Access Compliance Report

Public Rights-of-Way

Intersection ID: 27041	Main Street: ENDHAVEN_LN	Cross Street: ORCHID_HILL_LN	Location: NW
ADA ID: 32D67AEC753A	Ramp Type: Directional1	Initial Pass/Fail: Fail	Overall Compliance: No
		Severity Score: 10

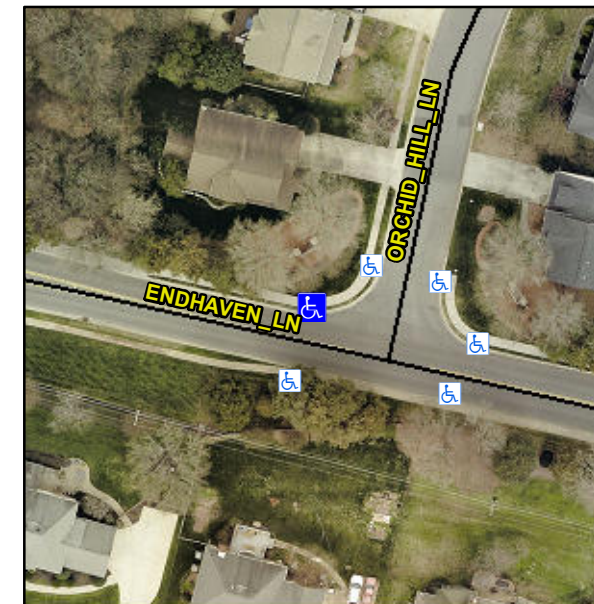
NO LNDG

R304.5.1

Remove & Replace Entire Ramp.
